Technical Service Bulletin

| Subject: KNOCKING NOISE FROM STEERING COLUMN WHILE DRIVING | Bulletin No.: 06-002/22 |

Replacement parts location**WARRANTY INFORMATION****NOTE:**

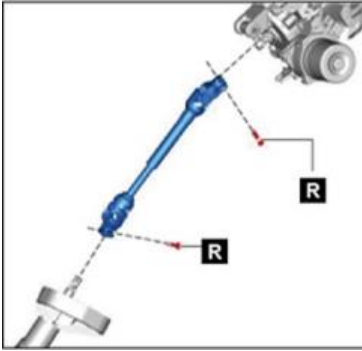
Some vehicle may exhibit a knocking noise from the steering column while driving. This may be caused by a gap between the intermediate shaft (upper side) and the joint bolt. To eliminate this concern, the intermediate shaft and the joint bolts have been modified to reduce backlash.

1. Verify the customer concern.
2. Replace the intermediate shaft with a modified one according to the instructions on MGSS (INTERMEDIATE SHAFT REMOVAL/INSTALLATION [US]).
3. Verify the repair.
